**GENOA CHARTER TOWNSHIP  
PLANNING COMMISSION  
PUBLIC HEARING  
JULY 14, 2014  
6:30 P.M.  
AGENDA**

<b>Attention:</b>	Mike Archinal, AICP Township Manager
<b>Subject:</b>	Buffalo Wild Wings Addition – Site Plan Review #2
<b>Location:</b>	900 Latson Road – west side of Latson Road, north of Grand River Avenue
<b>Zoning:</b>	MU-PUD Mixed Use Planned Unit Development District (with underlying zoning of GCD General Commercial District)

**Re: Buffalo Wild Wings Building Expansion  
Site Plan Review #2**

RE: Buffalo Wild Wings  
900 S. Latson  
Site Plan Review of Addition

**SITE PLAN FOR NEW ADDITION**

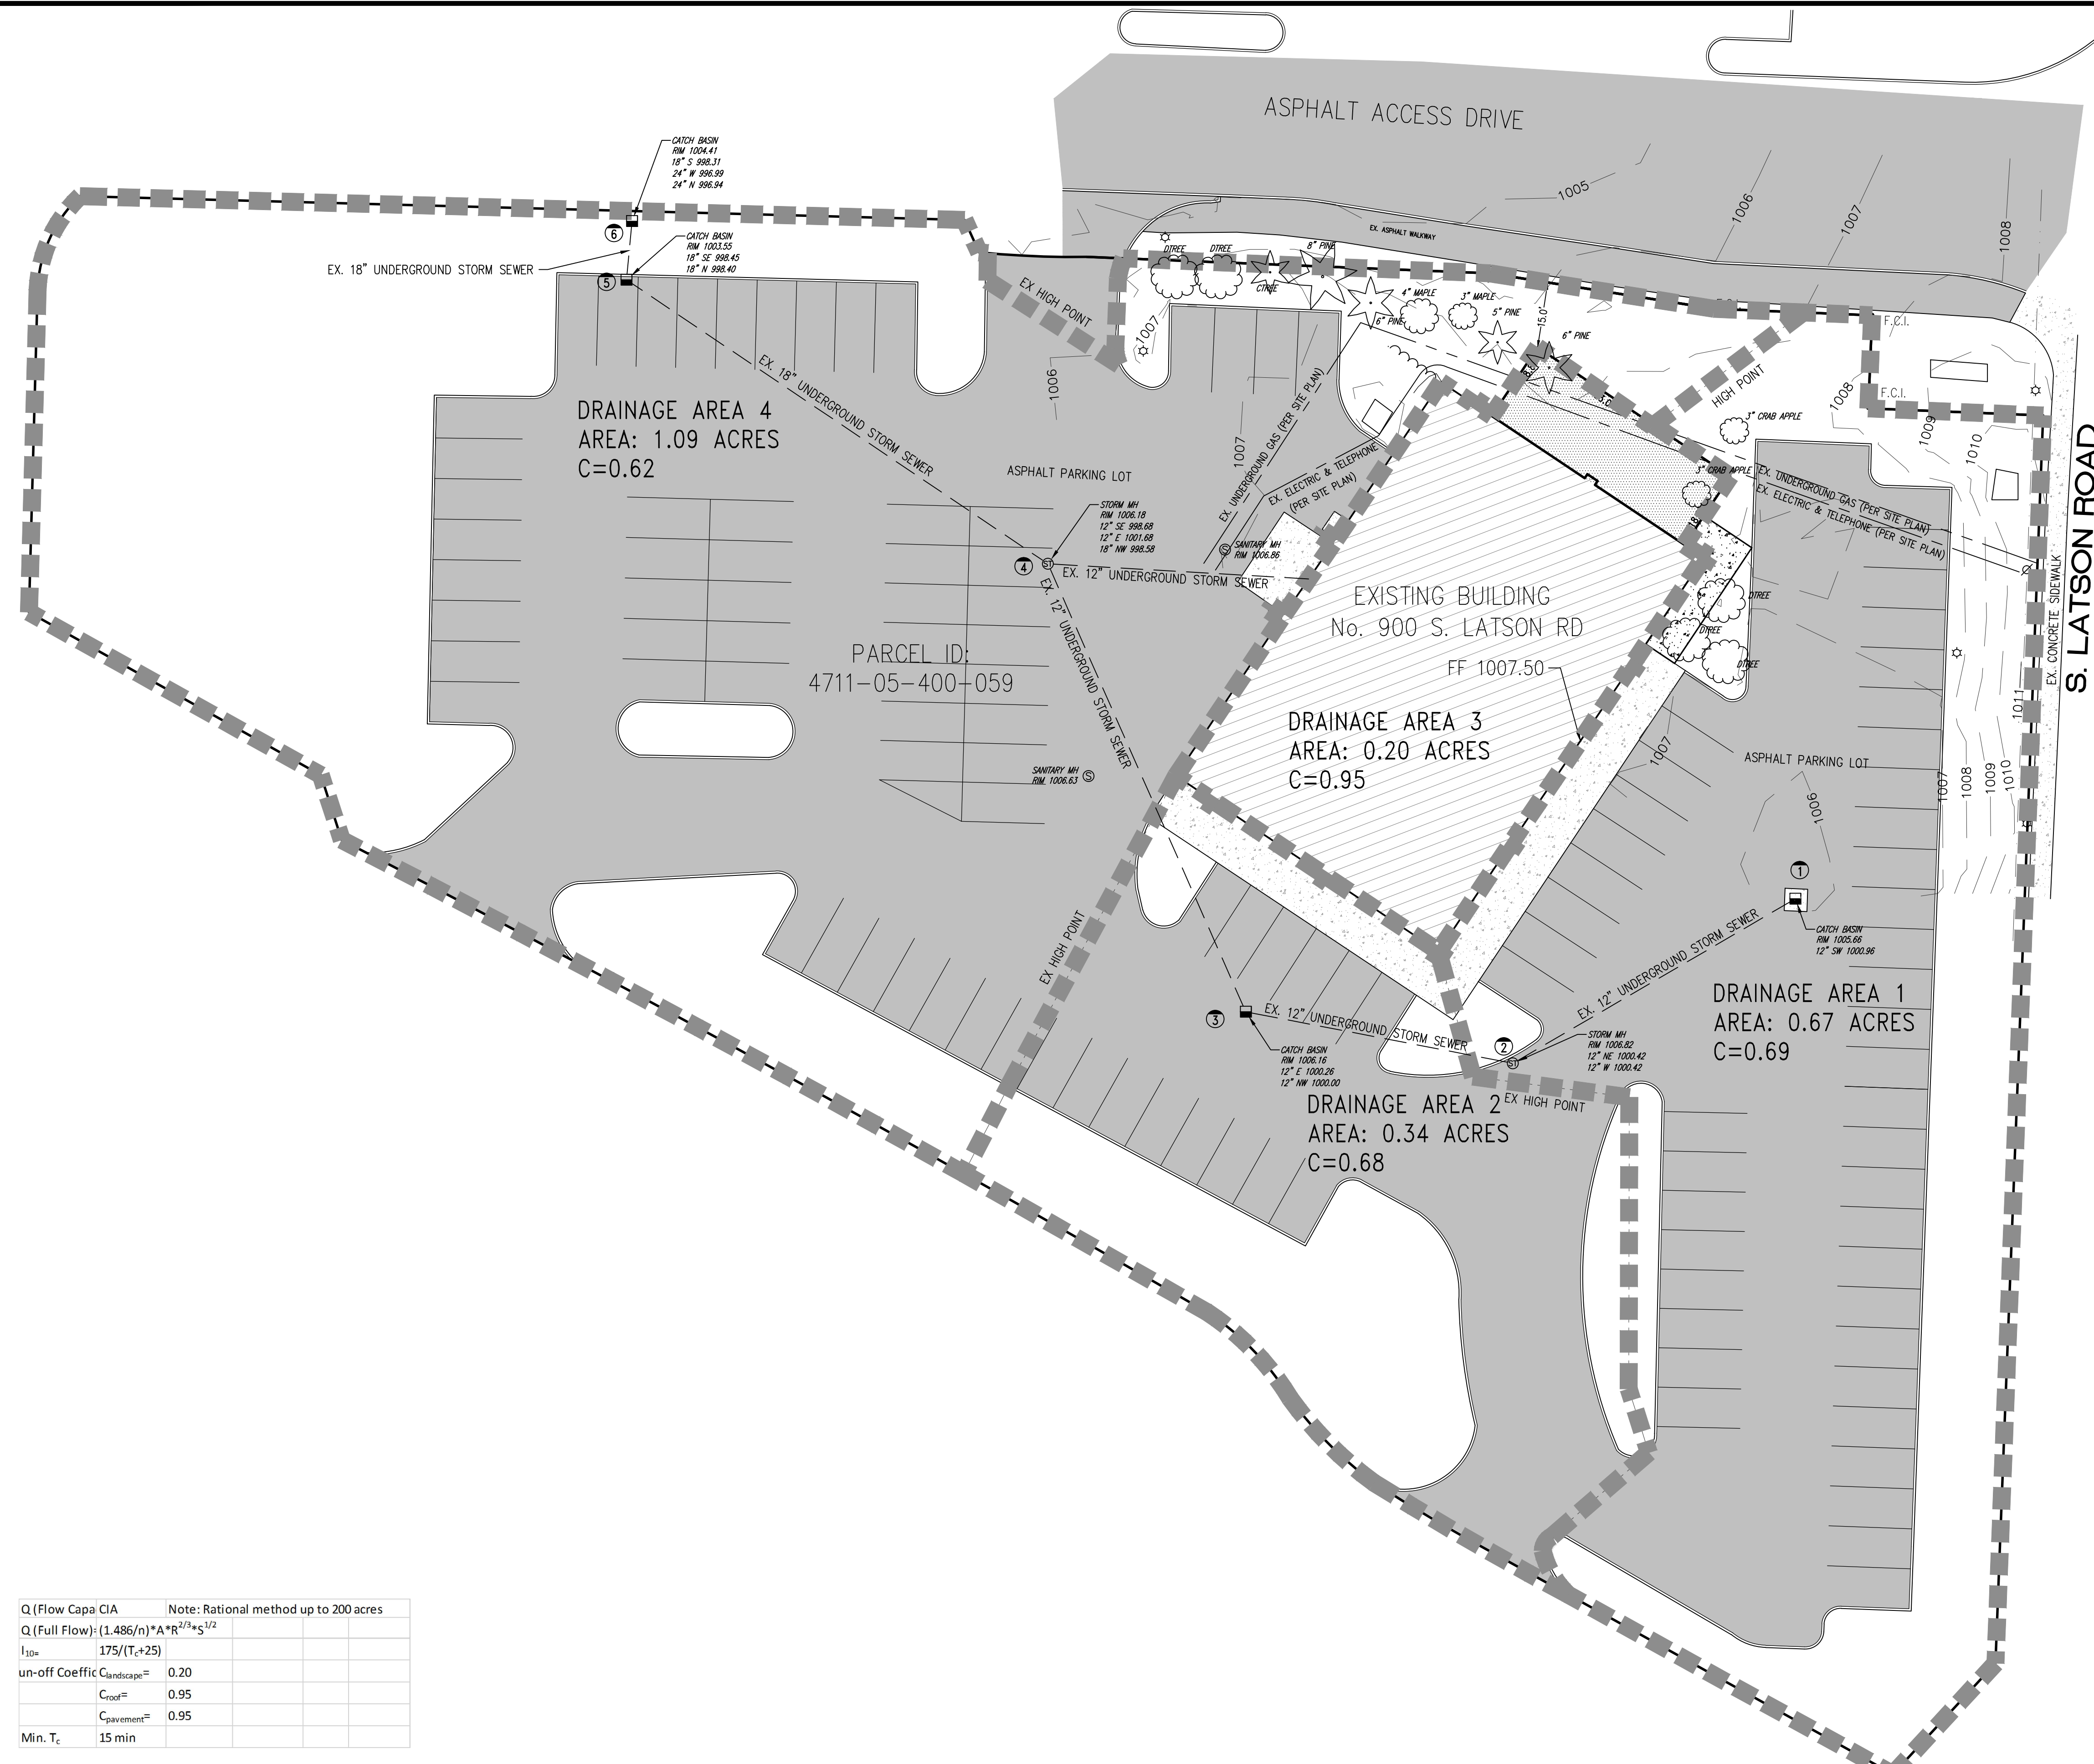
1. The proposed grading and curb cuts will adequately address the site drainage concerns; however, routing the flow to the parking lot catch basins will require some additional soil erosion control measures to be installed during construction. A complete soil erosion and sedimentation control plan should be submitted with construction plans.

The petitioner has successfully addressed the previous concern over site grading and drainage, and the site plan is recommended for approval. A soil erosion and sedimentation control plan must be included with the construction drawings.

project no.	sheet no.
<b>14020</b>	<b>A-200</b>

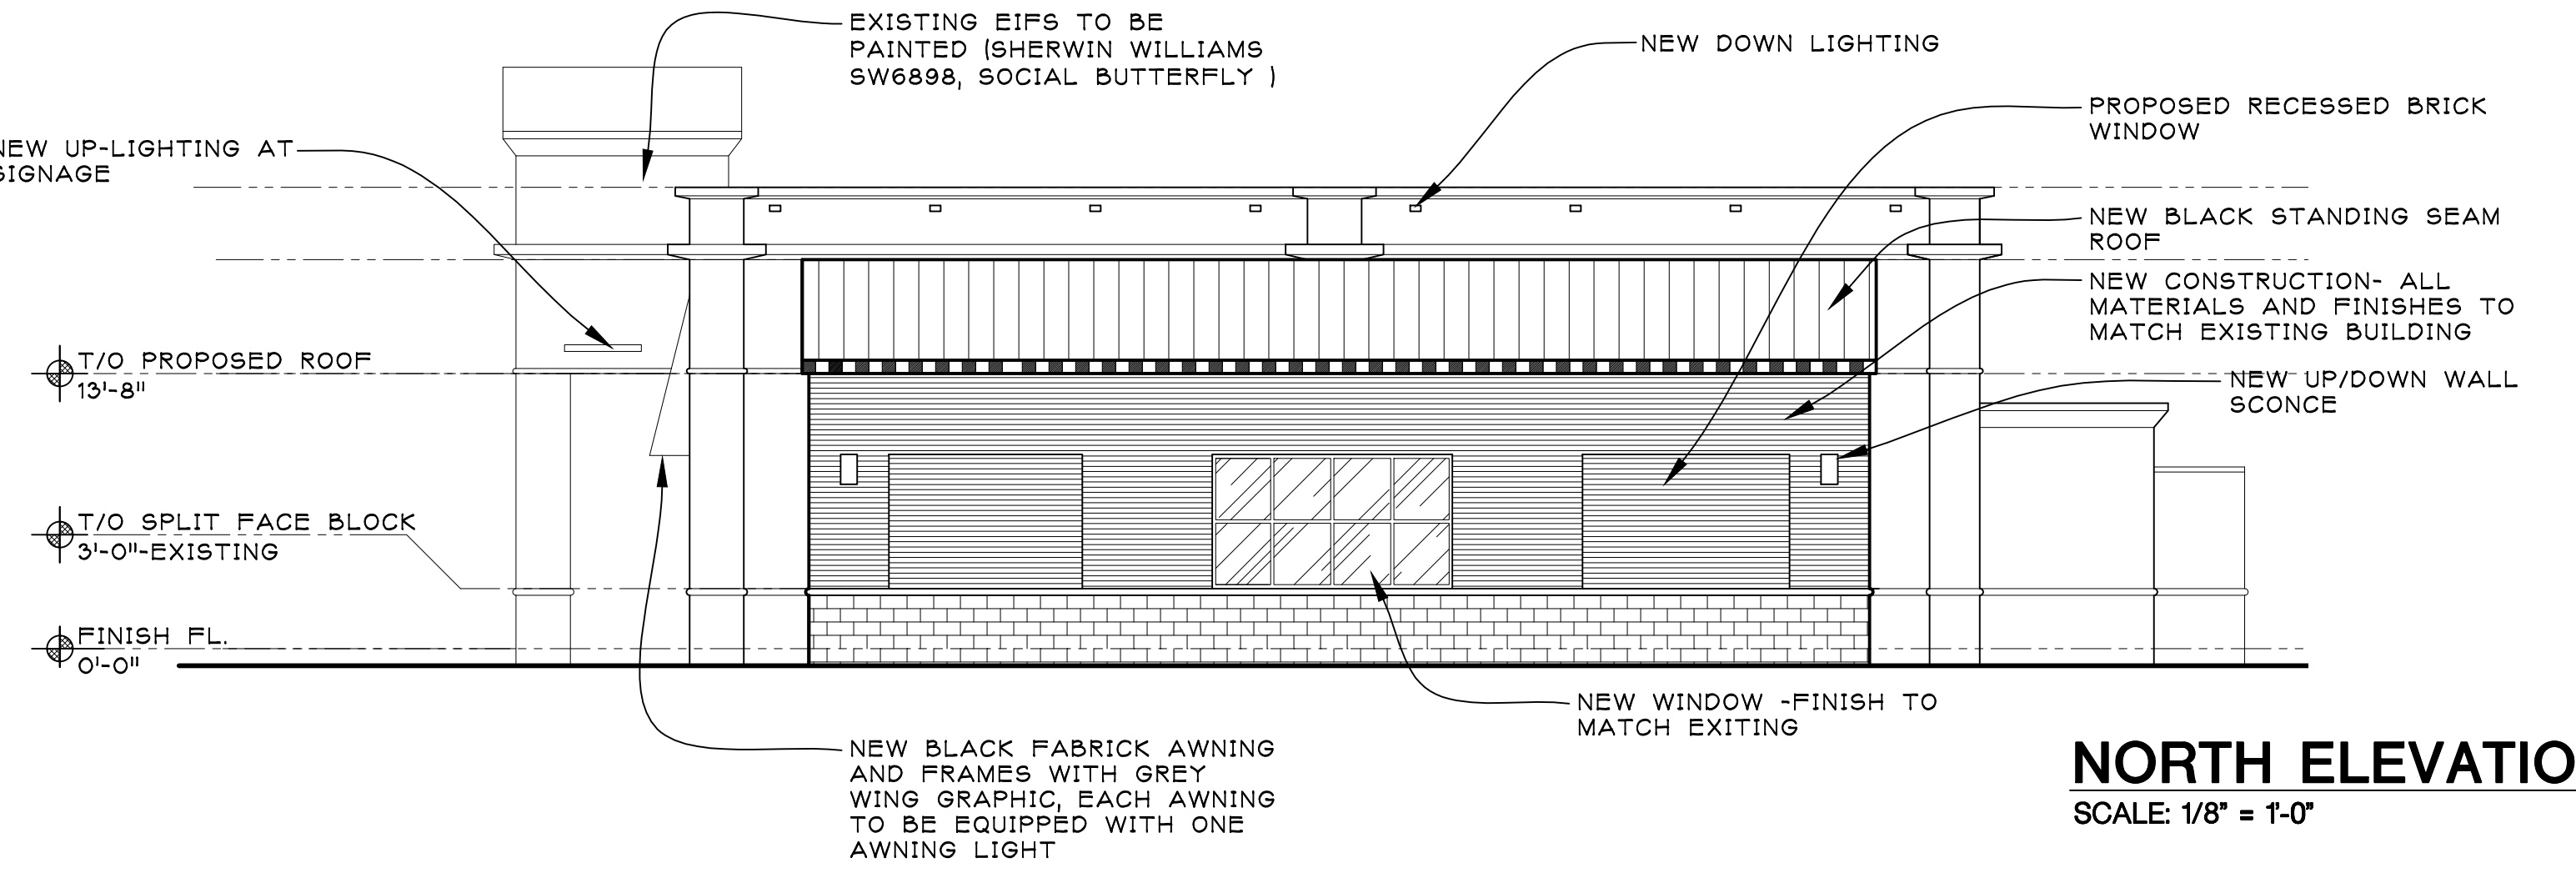
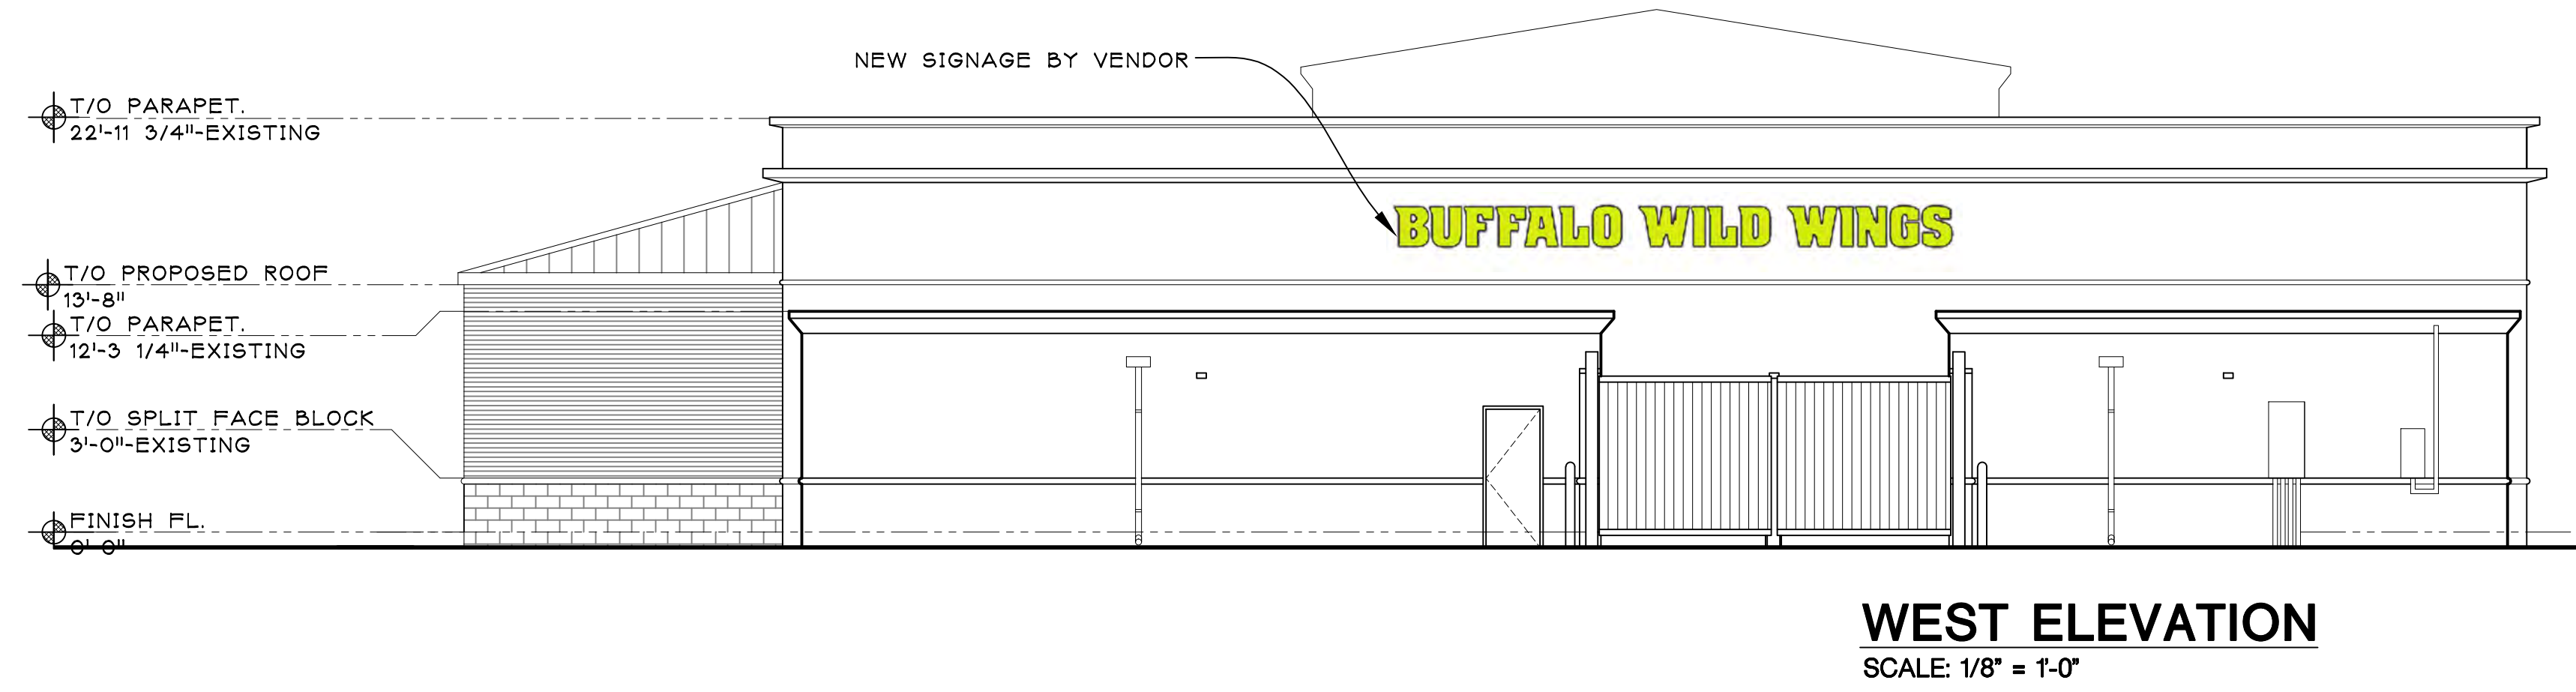
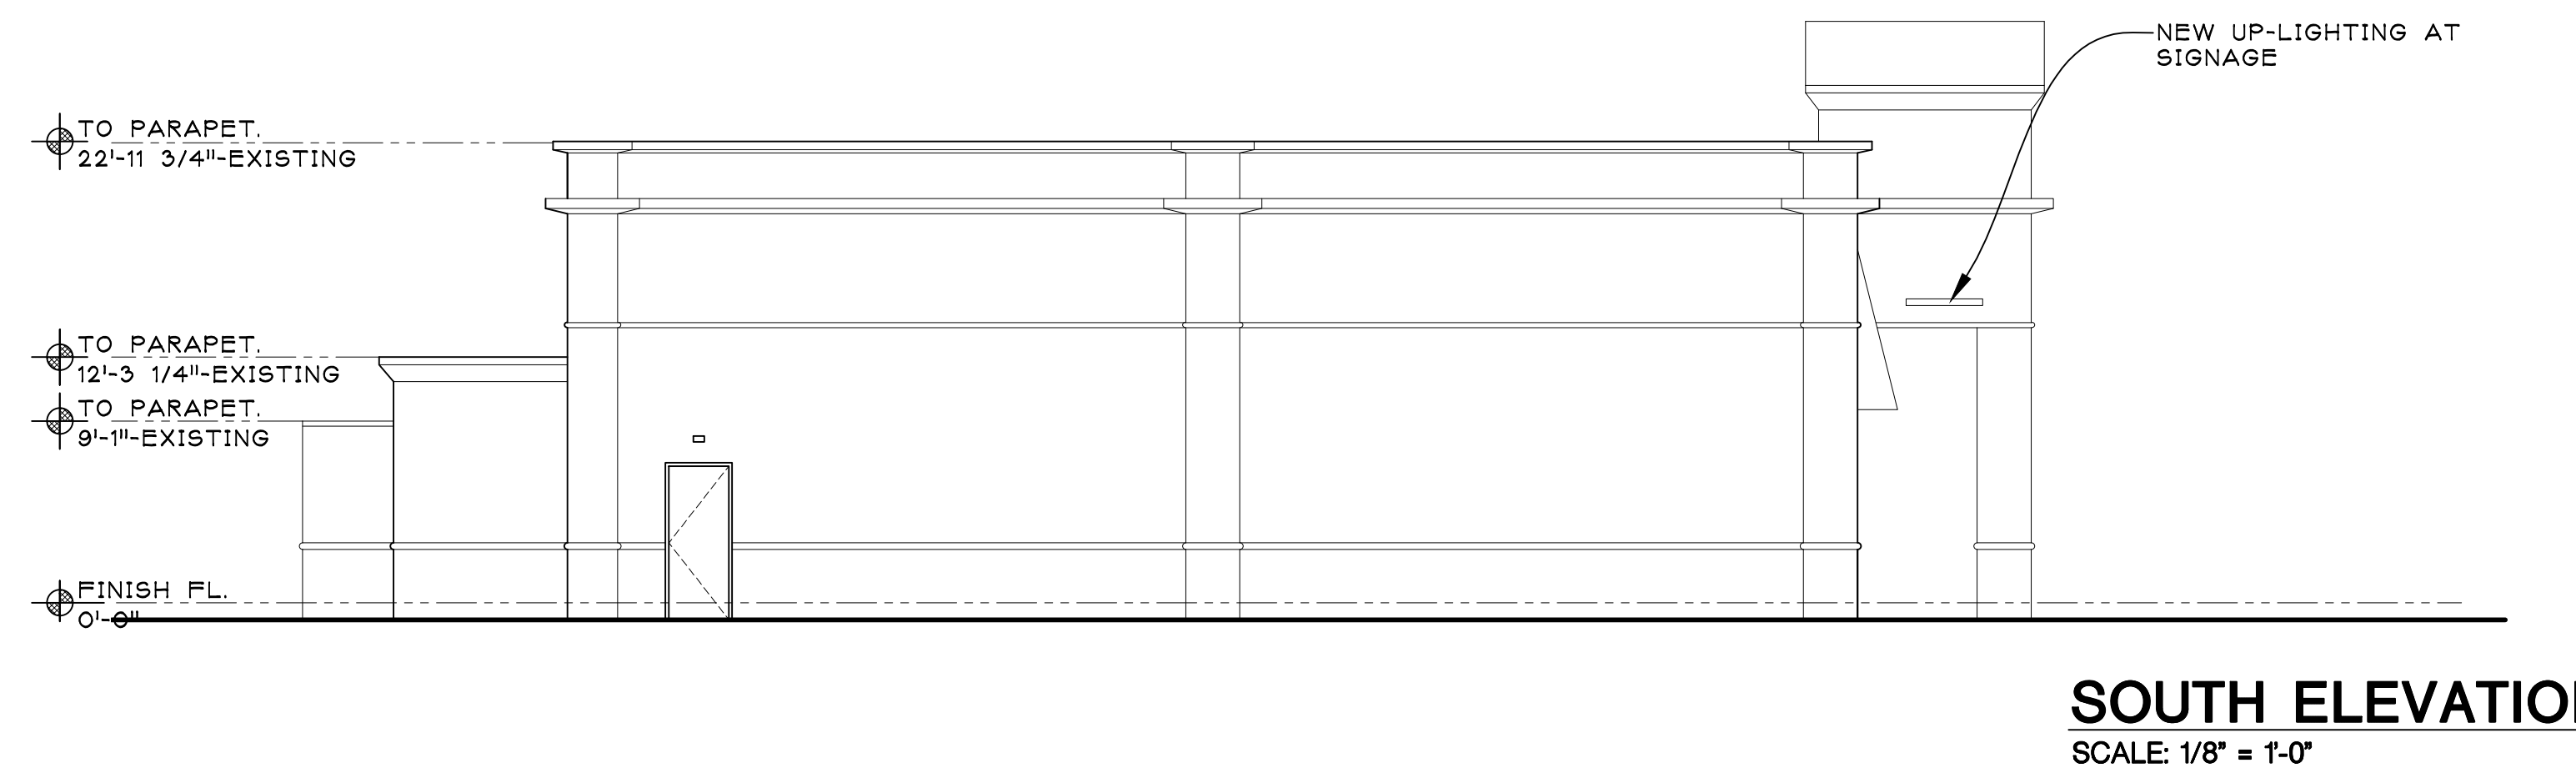
1. The applicant needs to provide details of the proposed wall mounted light fixtures.
2. The Planning Commission may allow a second wall sign, as proposed.
3. The total size of both wall signs (218 square feet) greatly exceeds that allowed (100 square feet).
4. The PUD Agreement requires the use of channel lettering for wall signs. The main entrance sign does not appear to meet this requirement.

10. **Signs.** The submittal identifies two wall signs (one each on the east and west building facades). Table 16.1 allows one wall sign, but gives the Planning Commission discretion to permit two due to constraints related to visibility or building orientation; however, both signs collectively cannot exceed 100 square feet in area.
